# Groundwater Application Review Summary Form

Application # G- 19377

GW Reviewer Phillip I. Marcy Date Review Completed: 03/21/2025

# PUBLIC INTEREST REVIEW FOR GROUNDWATER APPLICATIONS

**Cross-Section**

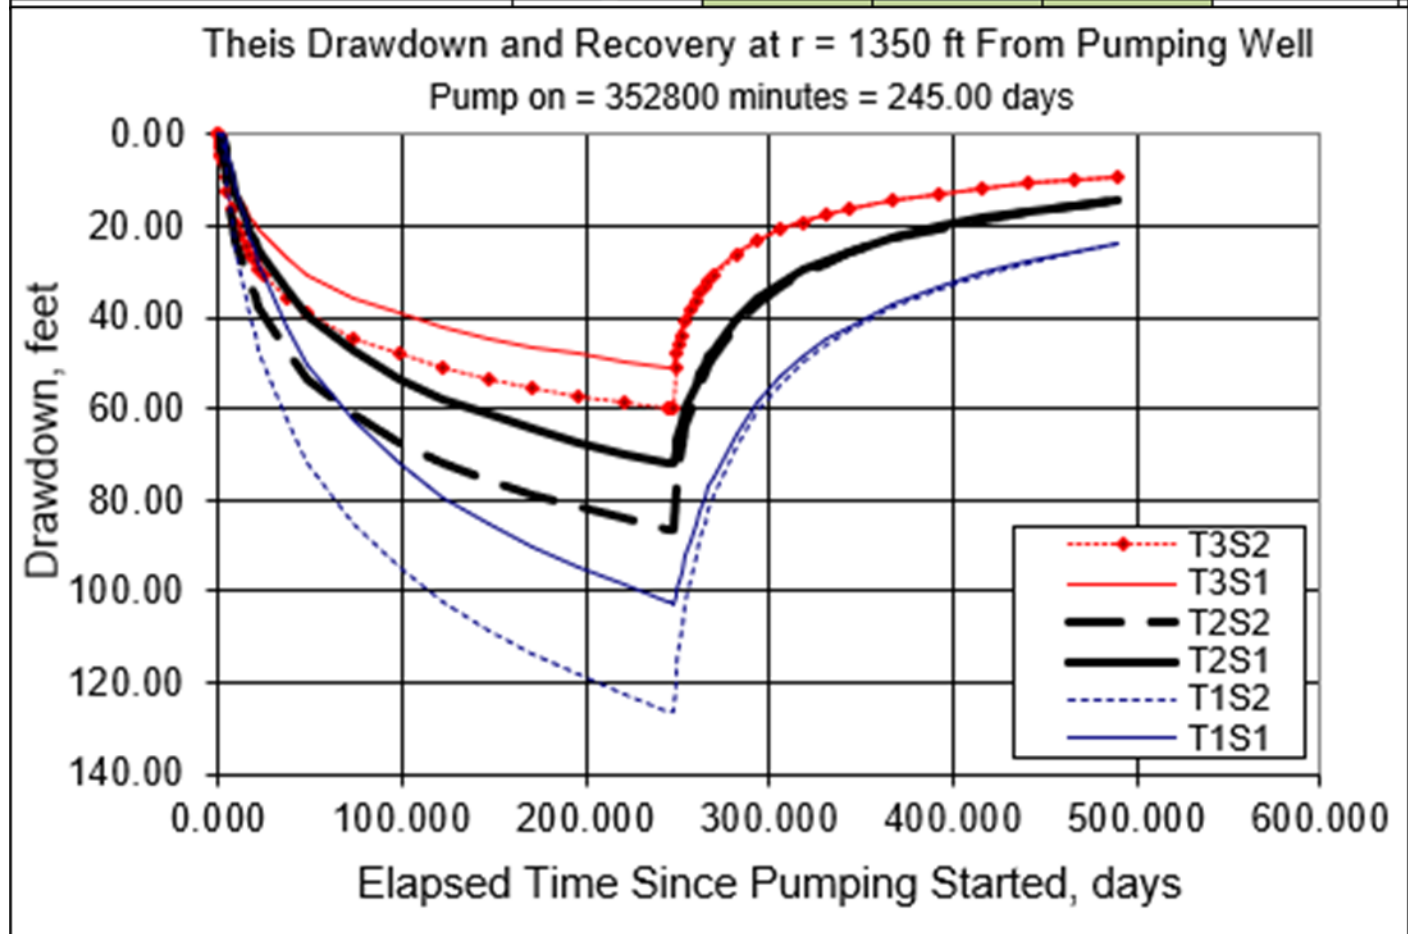
The proposed POA wells lie within a complex geologic setting with faults juxtaposing rocks of disparate ages and hydrogeologic characteristics on the eastern margin of the Baker Valley. The geometry of this contact is lost beneath the valley-fill alluvial sequence to the west, where there is little data available concerning the presence or depth of bedrock lithologies.

**Theis Interference Analysis**

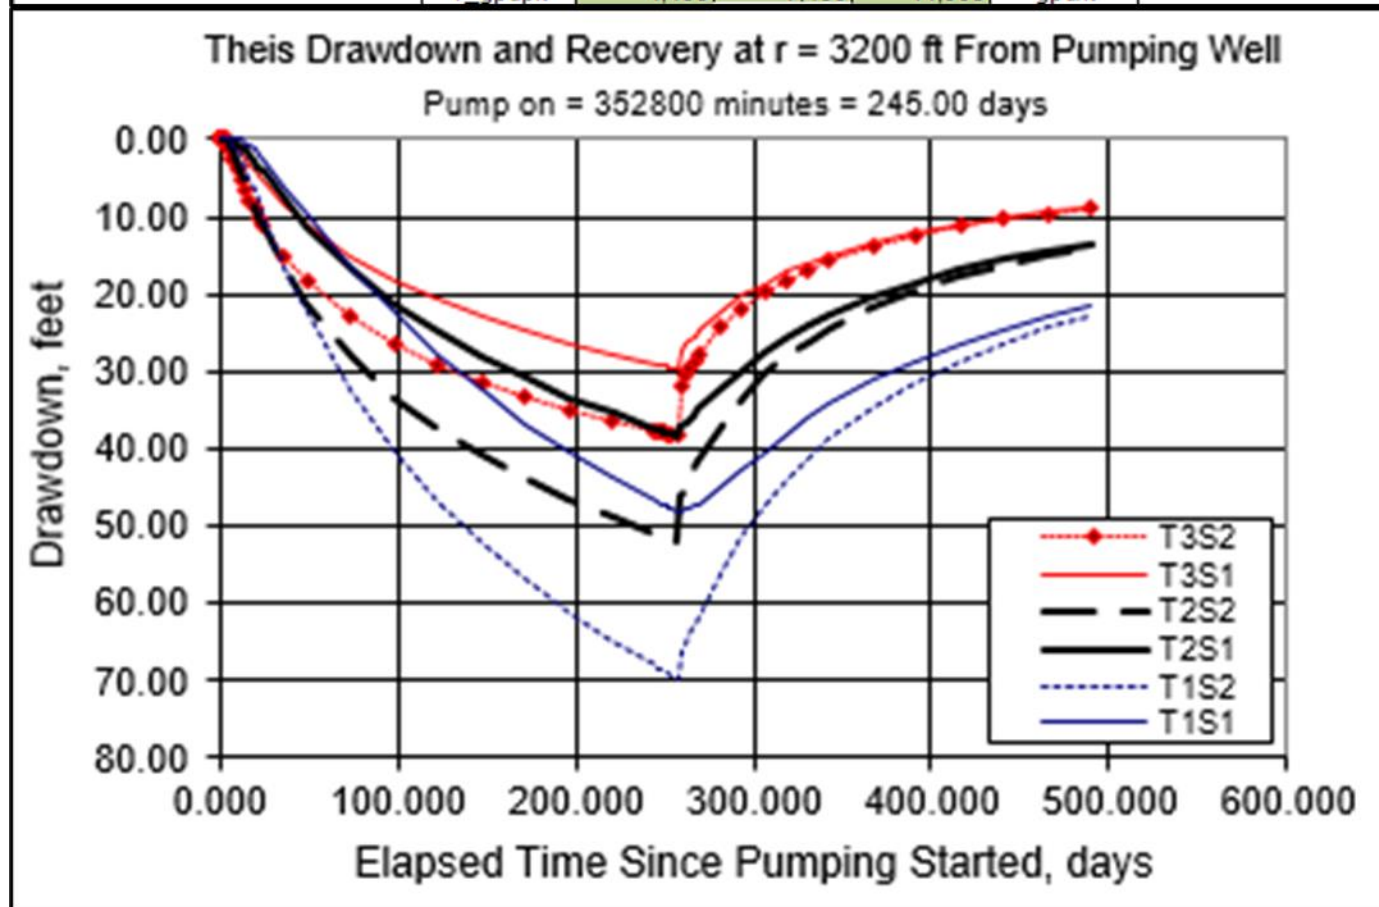
This time drawdown estimates of drawdown experienced at the nearest basalt well, BAKE 52526. This well belongs to the applicant and lies on the same tax lot as the nearest POA well.

This time drawdown estimates of drawdown experienced at the nearest basalt well not belonging to the applicant, BAKE 51968. A plurality of estimates fall between 35-50' of expected drawdown at this well based on the most liberal pumping regime from the nearest POA well.
